Planning Commission

Meeting Minutes

May 15, 2017

FDM-22-2017 Final Development Plan Modification

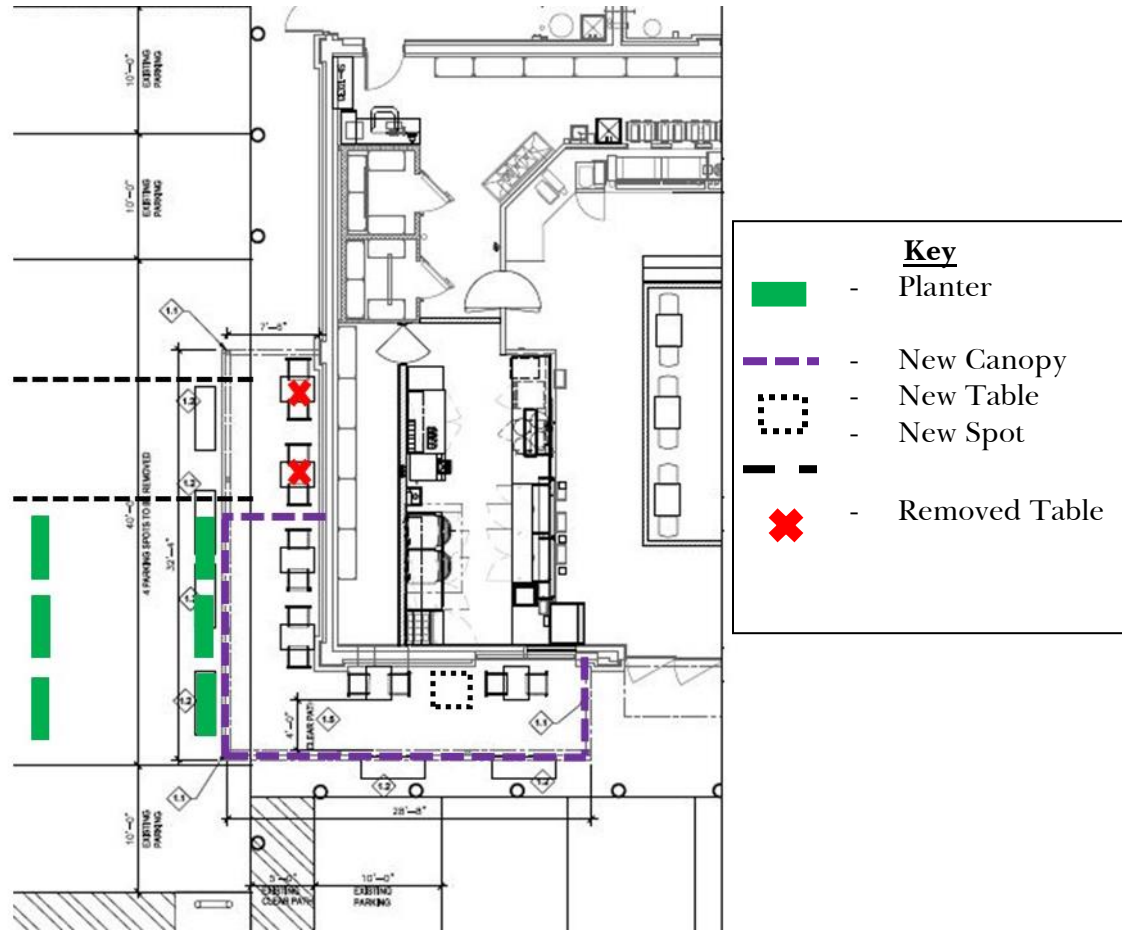
1. The final development plan modification proposes to remove four existing parking spaces to add outdoor furniture, planters, and a canopy.
2. The applicant has submitted two options for the canopy area. The alternate has a smaller canopy and seating area in the front of the building. Both options propose the same modifications to the parking lot on the side of the building.
3. The total lot coverage will not be changed.

4. The existing parking spaces are dimensioned 10 feet wide and 19 feet deep. Currently the awning and planters encroaches 4 feet into the existing parking spaces that are to be removed. The plans do not indicate what is proposed for the remainder of the removed parking spaces. The Planning Commission should evaluate the appropriateness of the parking lot design. Staff recommends a condition of approval requiring the area is striped or additional planter boxes are added to the end removed parking spaces to ensure customers do not try to parking in this area.

5. The City Engineer commented that “there is approximately 174 inches of paved area available adjacent to the proposed planters.”
6. Staff recommends decreasing the length of the canopy down the side of the building and shifting the tables from the side of the building to the front. Staff believes that as a result two less parking spaces will have to be removed and the canopy can still accommodate at least five tables. The diagram below shows the shorten canopy on the side of building so it terminates in the middle of the wall’s architectural projection. Since two parking spaces are removed, this results in a smaller remaining area that the applicant could use for additional seating and planters.

1. The submitted plans show a black canopy with wood column supports. Staff recommends the Planning Commission evaluate the appropriateness of the unpainted wood columns. The majority of the building is brick with black and red accents. Staff recommends that the wooden column supports be painted black to be consistent with the existing building design and surrounding area.
2. Dairy Queen, who is also located in the Canini Trust Corp, has an outdoor patio area with a black stained pergola made also of wood.
3. Applicant proposes to add six or seven planters to delineate the seating area.

1. Final lighting specifications are subject to staff approval.
2. The wood columns are painted black to match the preexisting building design.
3. The final canopy design is redesigned based on staff's recommendation so there are only two parking spaces removed and the canopy length down the side of the building is shortened.
4. Planters or striping are added along the drive aisle to the area where parking spaces have been vacated.
